CITY COPY
16350 MIDWAY RD

PROPOSED FACILITY FOR:
BAS REALTY
LIMITED PARTNERSHIP

4-20-95

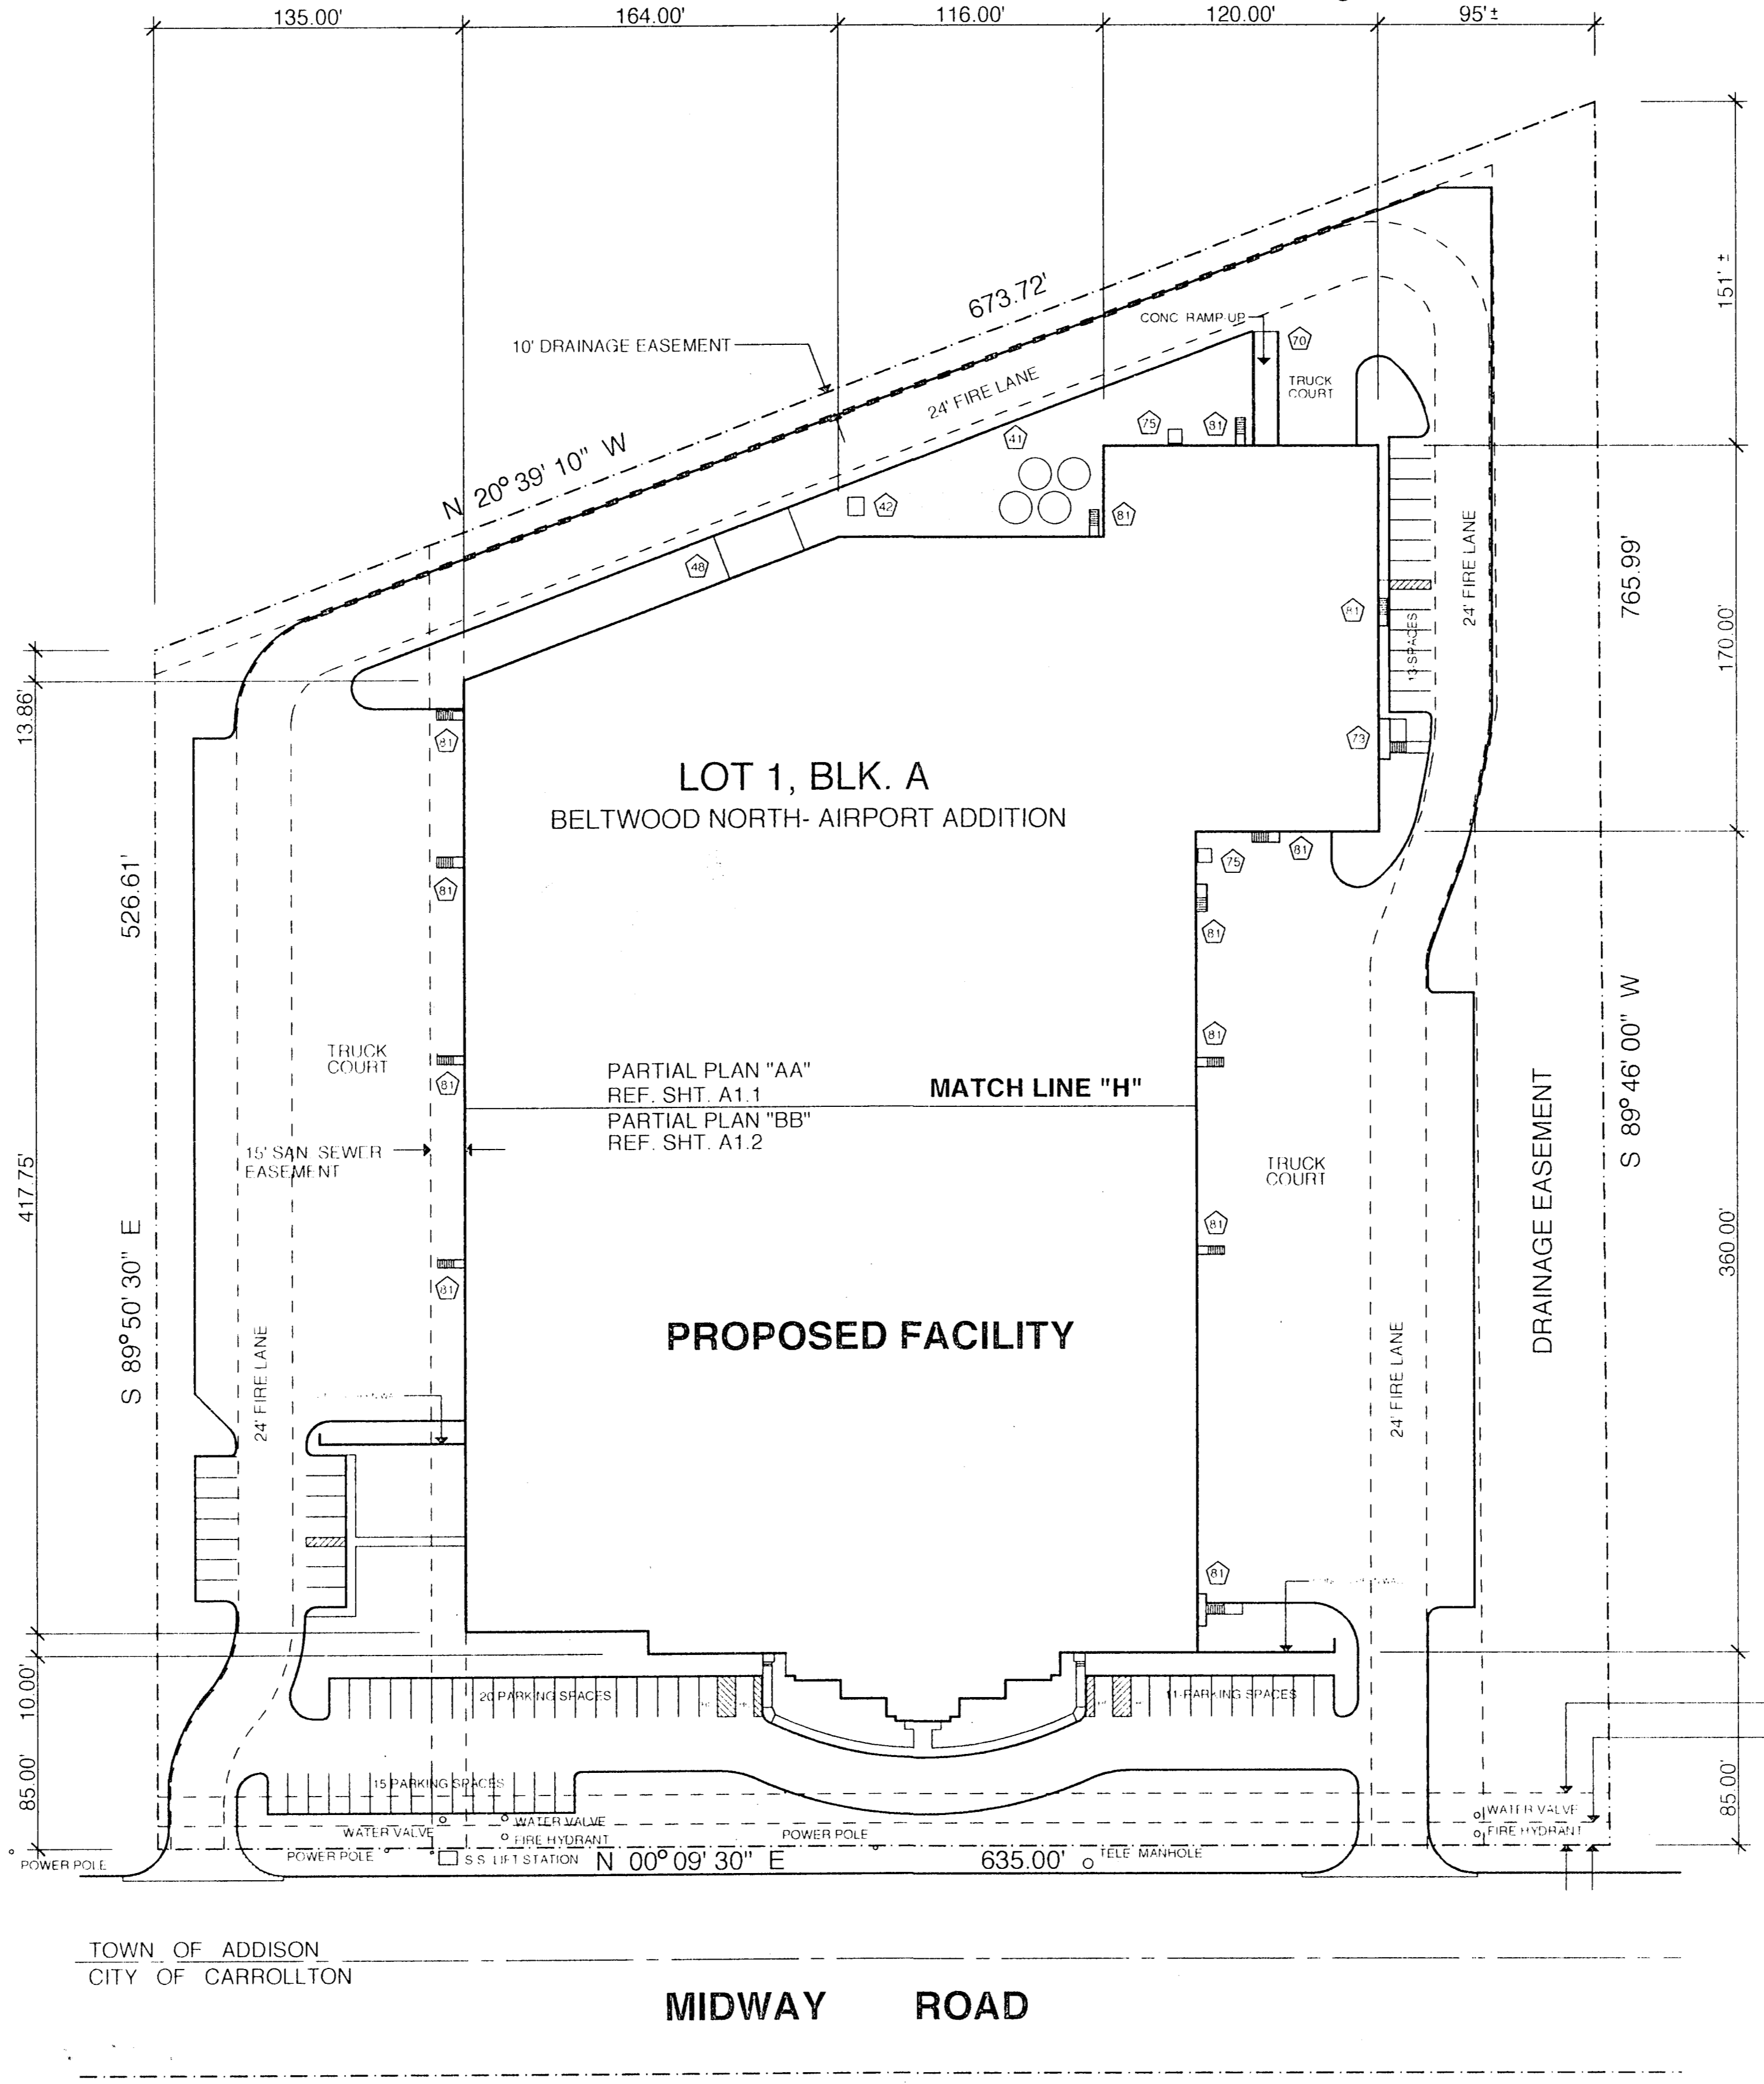
*Domestic under to have double check
Add vent to S. Trap see p. 20.*

*no problems
OK grading foundation*

OK PER PHONE WITH RON LEE.

1. UPON COMPLETION OF PROJECT ARCHITECT MUST SUBMIT A LETTER STATING THAT BLDG AND SITE MEET THE ACCESSIBILITY REQ. OF CH 31 OF THE 1991 LBC

01 PARTIAL FOUNDATION PLAN - B

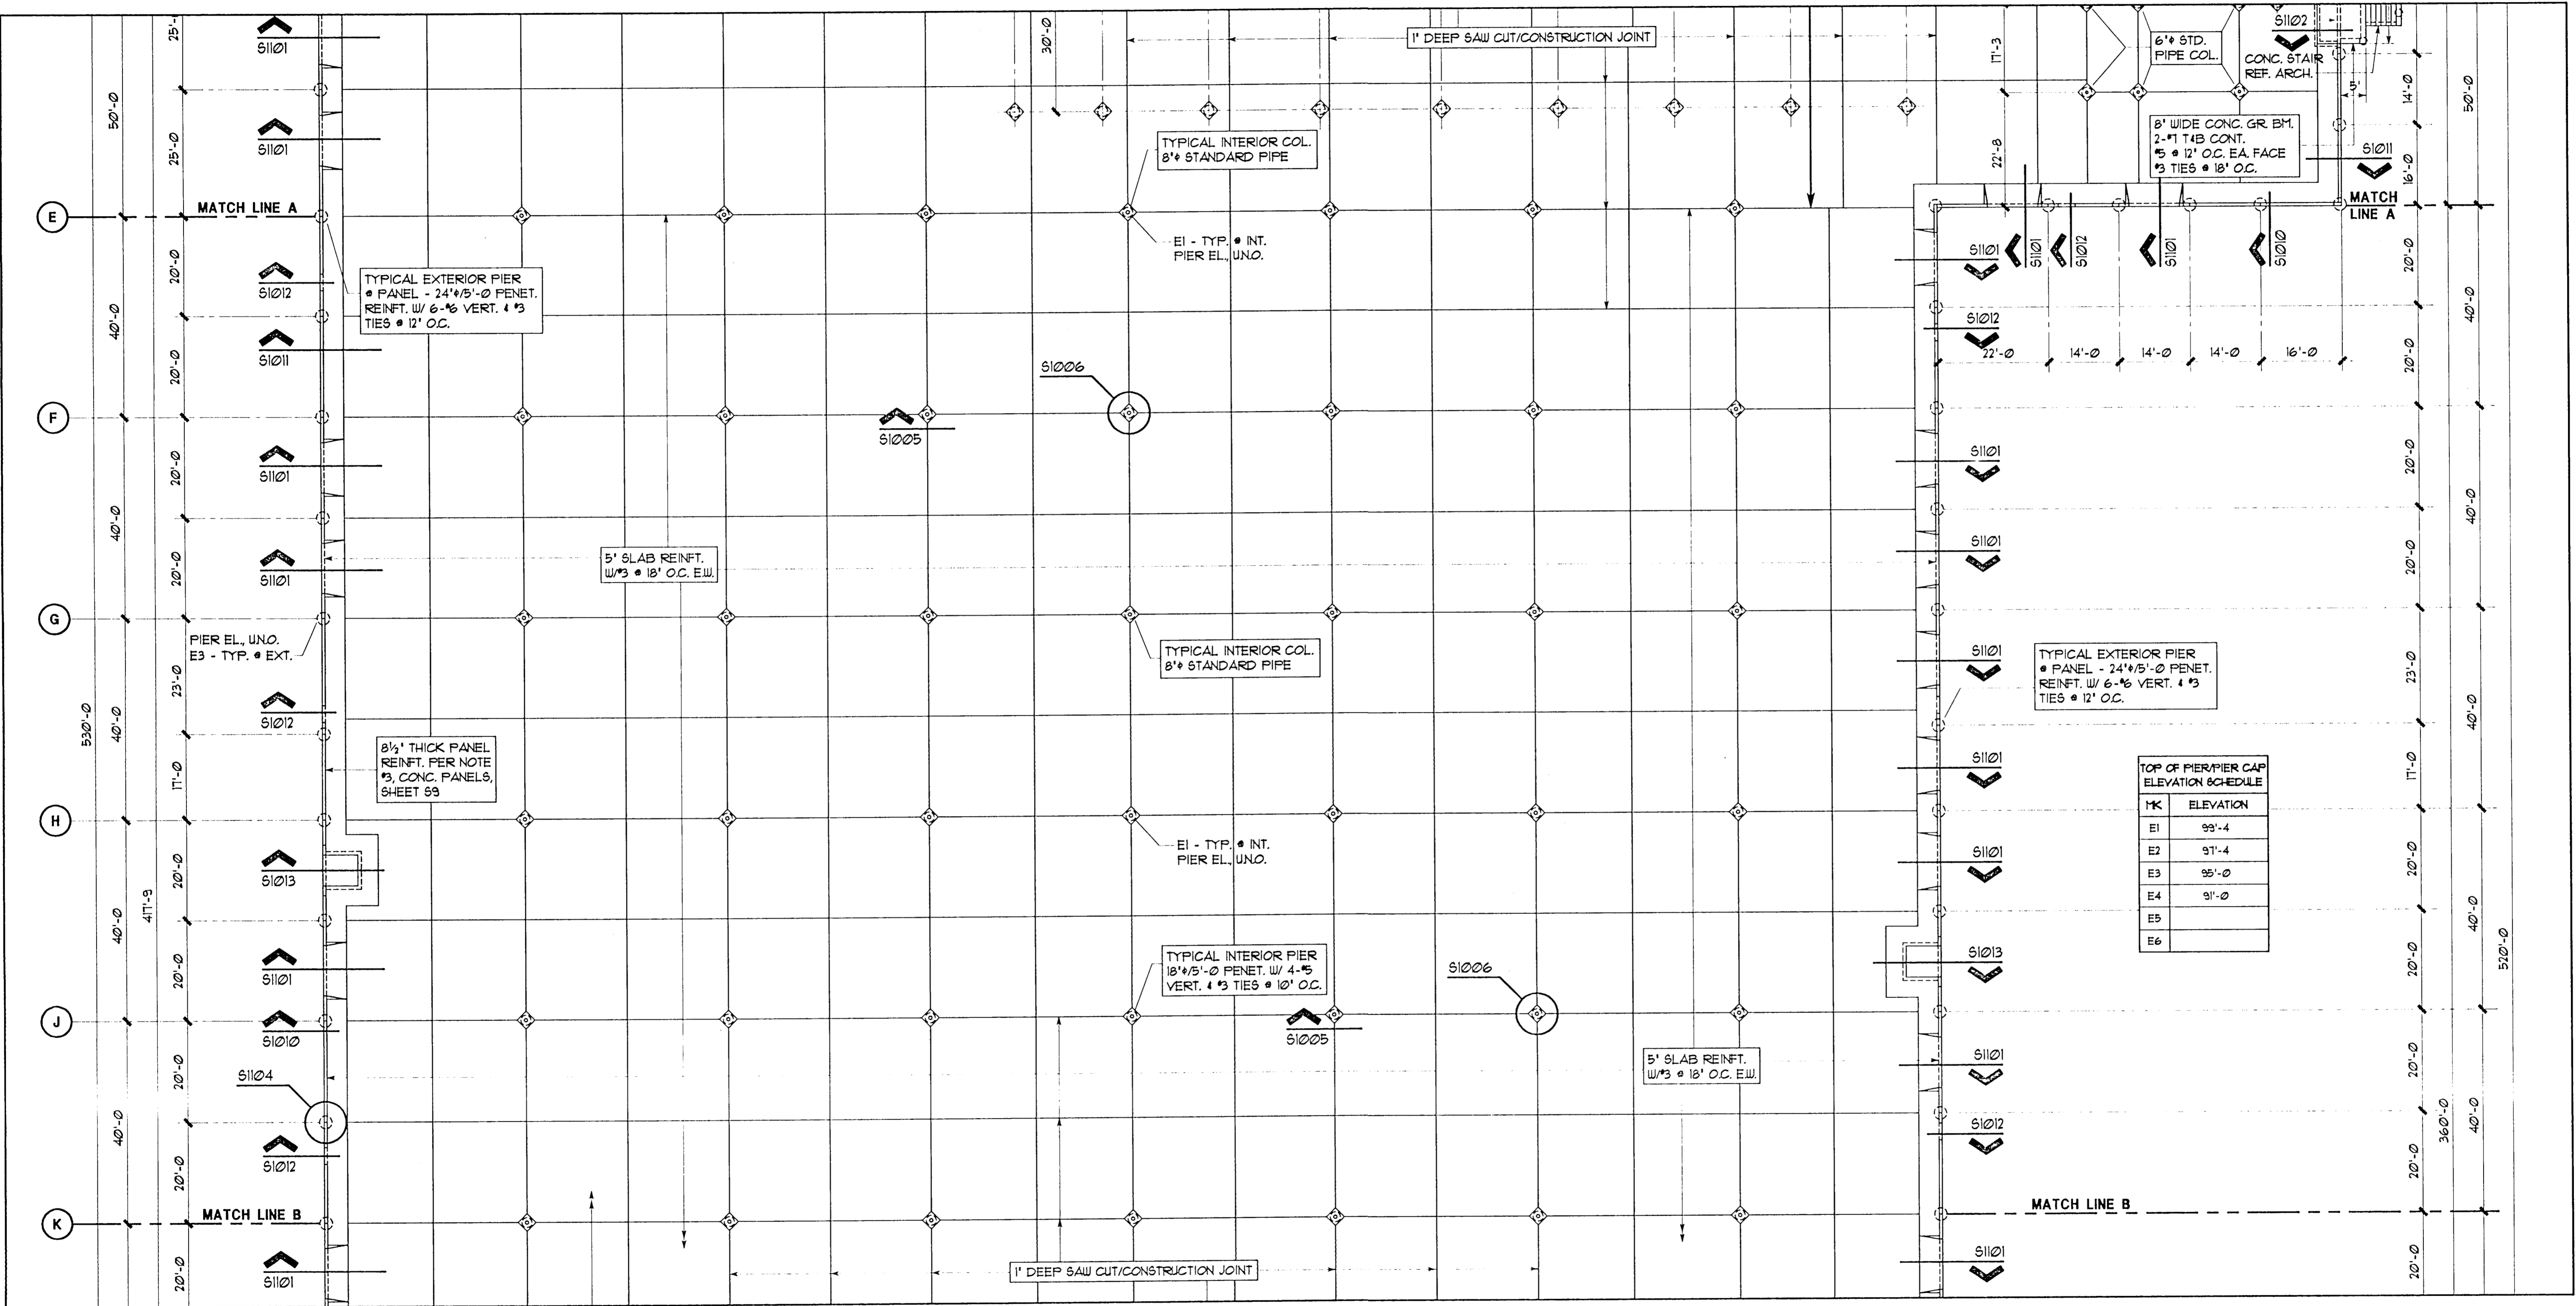
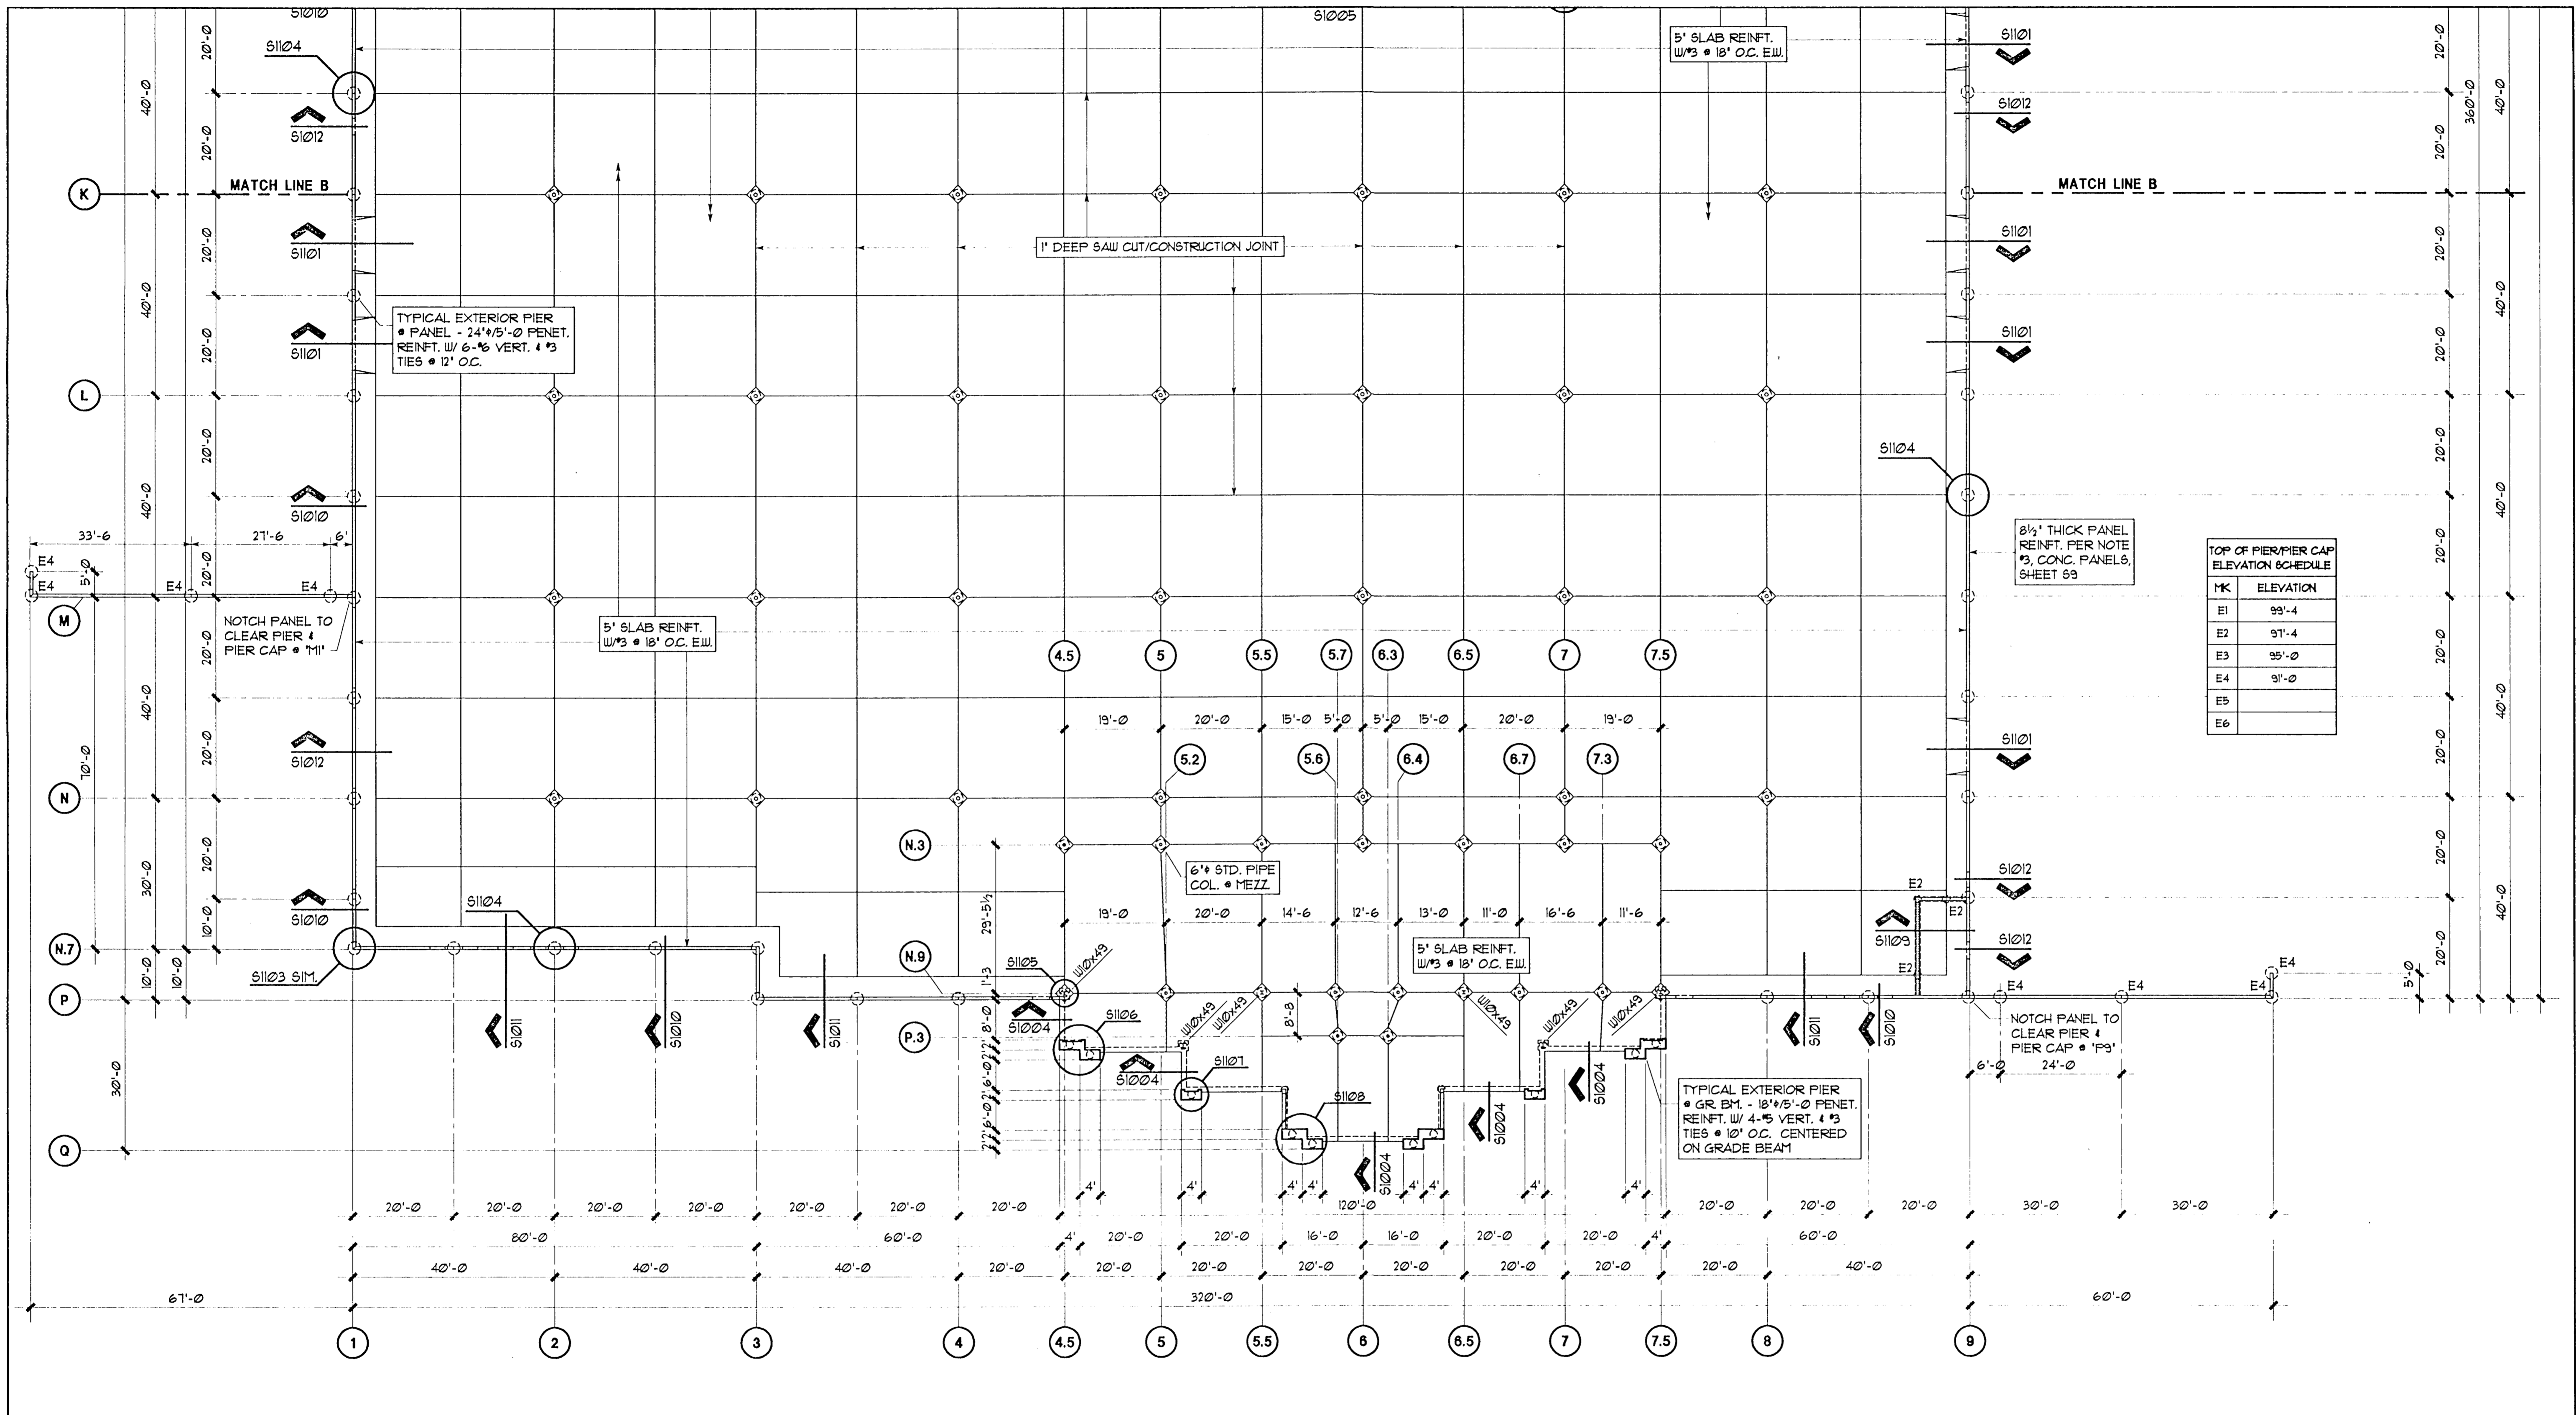
- SPECIAL INSPECTOR REQD.
- ENG. MUST SUBMIT LETTER UPON COMPLETION OF PROJECT STATING BLD WAS CONSTRUCTED PER PLAN.
